SERVICE BULLETIN

M-1408D August 28, 2015

2014-2015 TOURING SADDLEBAG MOUNT - SAFETY RECALL 0166

Reason for Revision

Figure 1. Saddlebag Stud Receptacles (shown inverted from installed position)

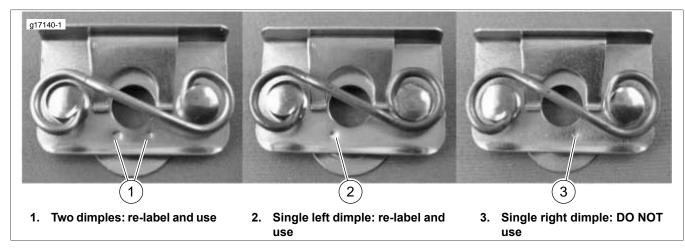
- 1. Inspect all dealer inventory of kit 91500084.
 - If package has a date code of 07/14/15 or earlier, parts are good. Add an "A" after the part number.
 - b. See Figure 1. Inspect all later date code inventory of kit 91500084 as shown in Figure 1.
 - c. Add an "A" to all kits that pass inspection.
- For kits that fail inspection, see 91500084 KIT RETURN PROCESS.

Some kits have stud receptacles with a green paint mark. All kits (Part No. 91500084A) are approved for use, including those containing receptacles with a green paint mark.
